**Monterey Bay Aquarium
Research Institute**
7700 Sandholdt Road, Moss Landing, CA 95039

Schematic Name: Subsea Bottle		Engineer: <Engineer>
Page Title: Dock Subsea Bottle 2023		Designer: <Designer>
Project Name: <Project Name>	Group Name: <Group>	Last Updated By: <Updated By>
System: <System>	Subsystem: <Subsystem>	Sheet: D
Drawing Number: <MBARI INT>	Release: A	Version: <Version>
Page Modified Date: Monday, September 18, 2023	Check-In Date: <Check-In>	Sheet: <Page Number/Total Pages>

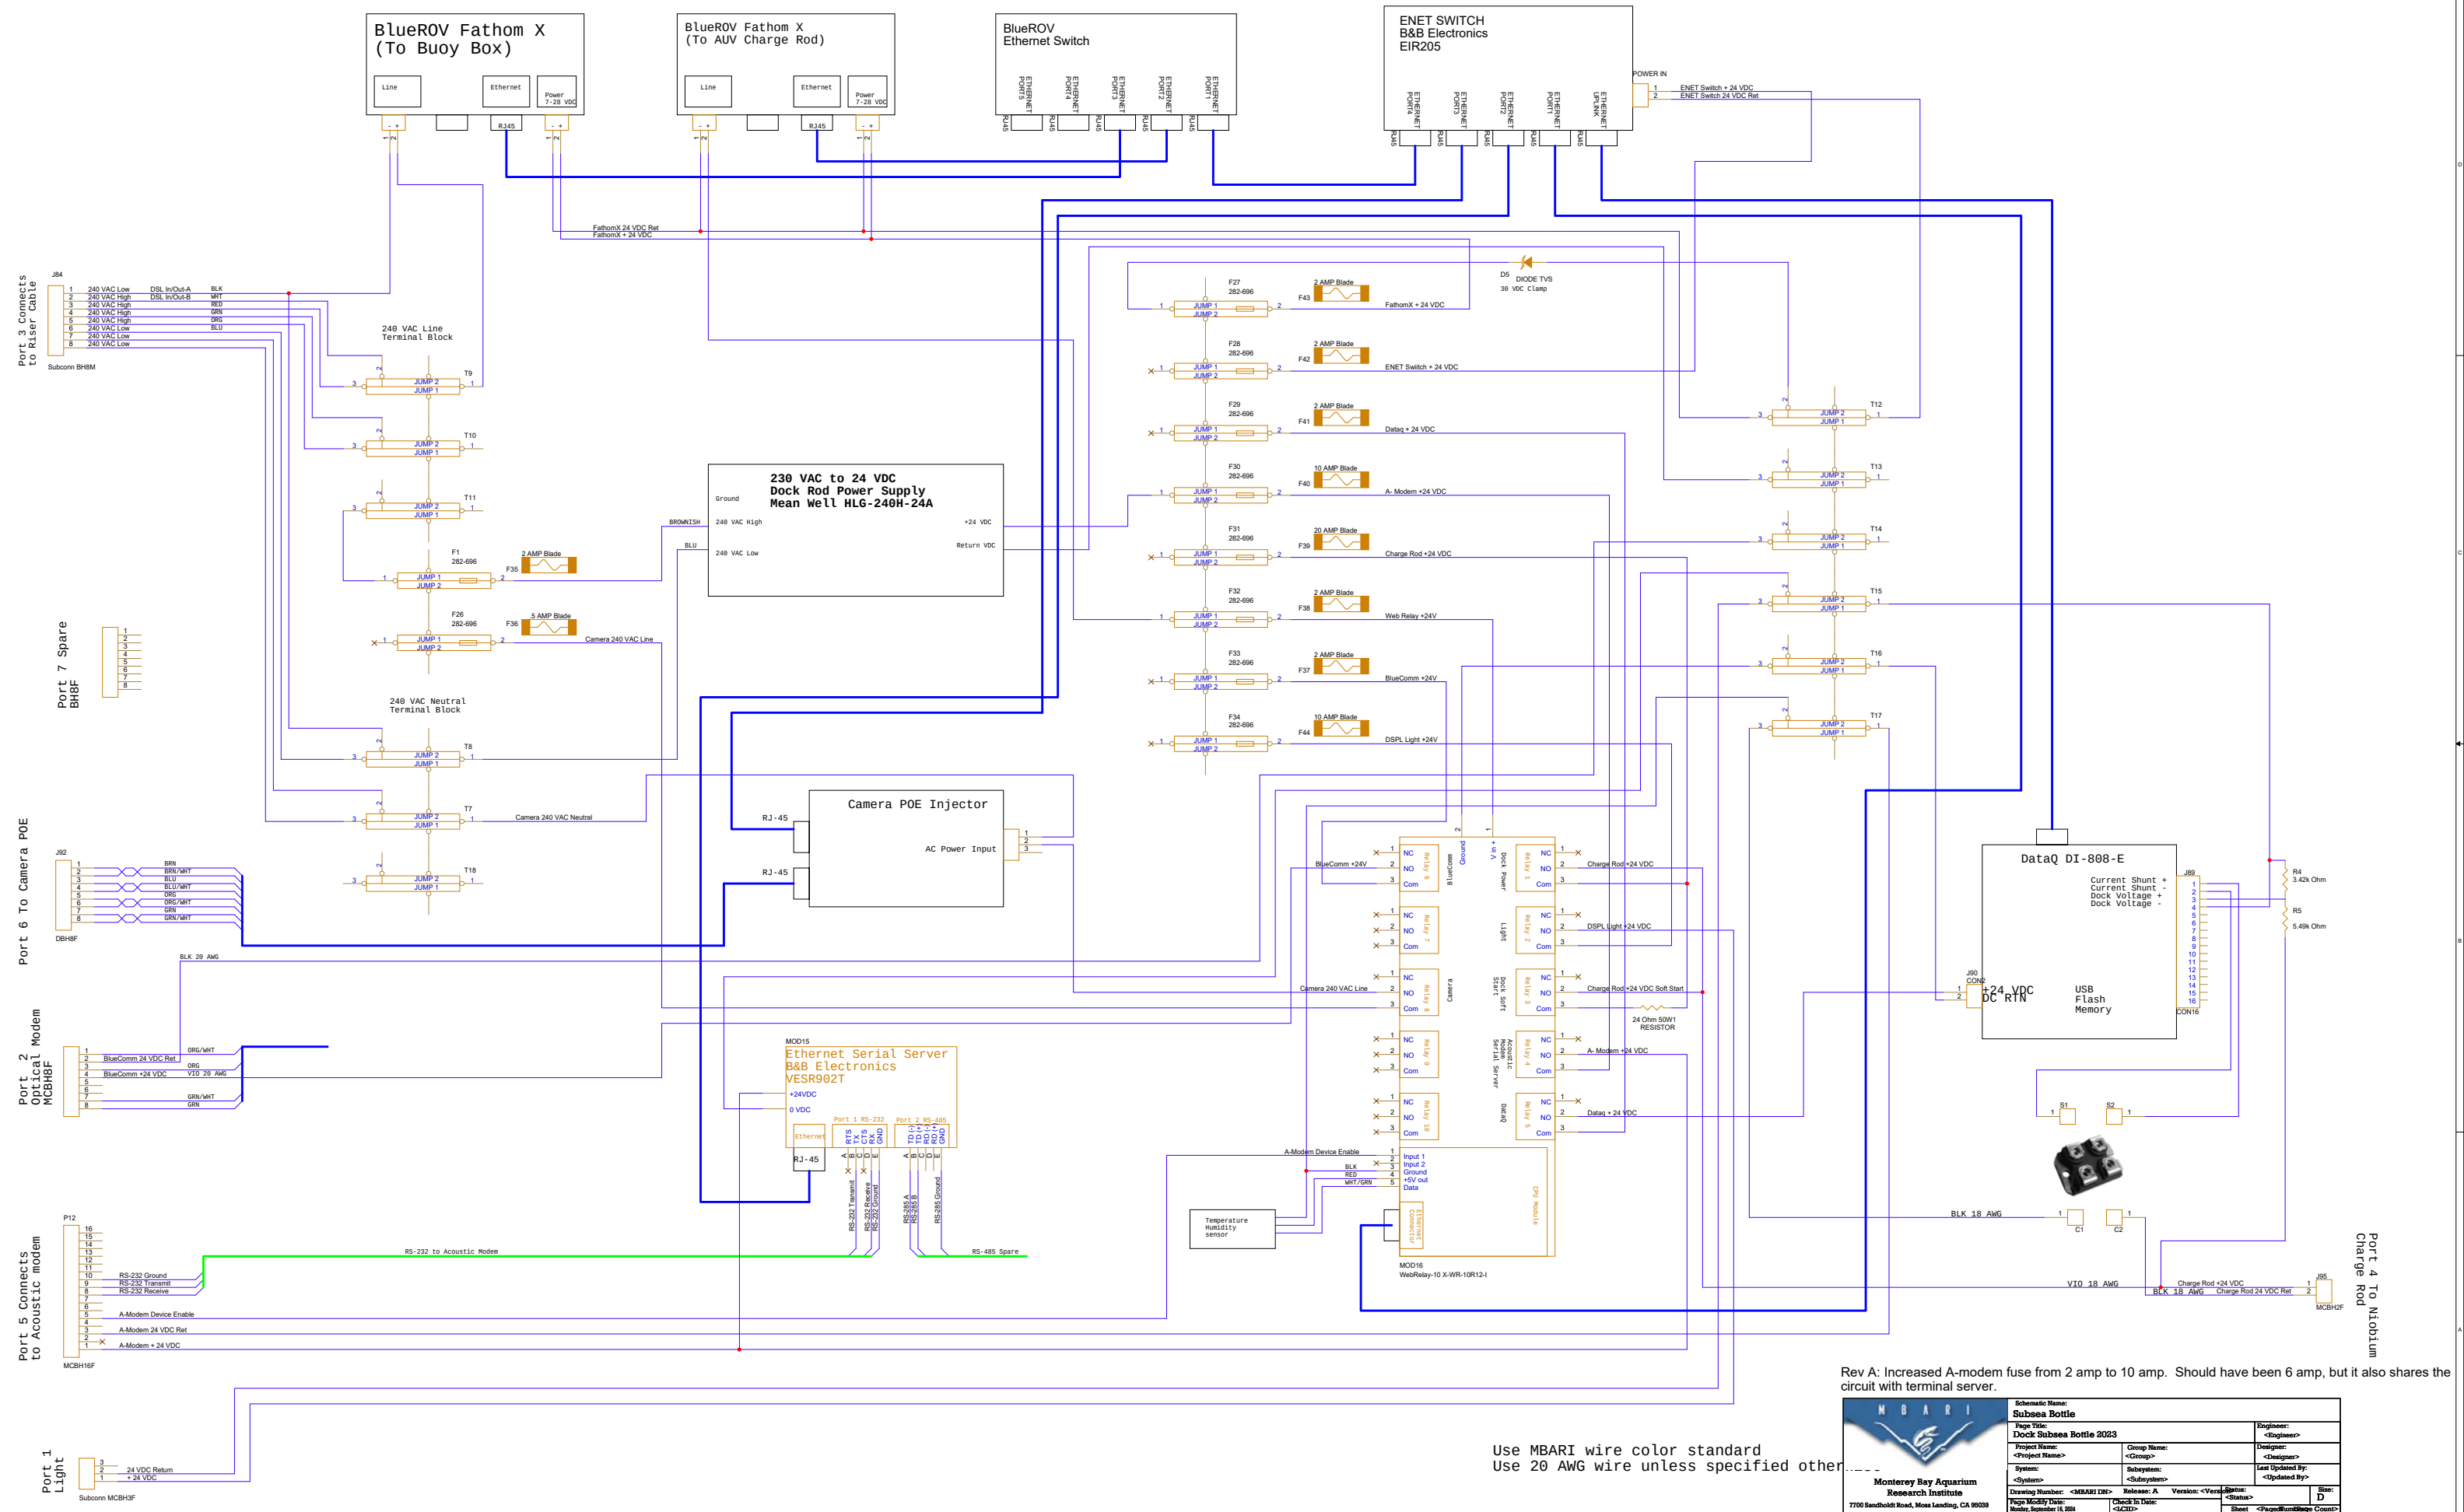
Rev A: Increased A-modem fuse from 2 amp to 10 amp. Should have been 6 amp, but it also shares the circuit with terminal server.
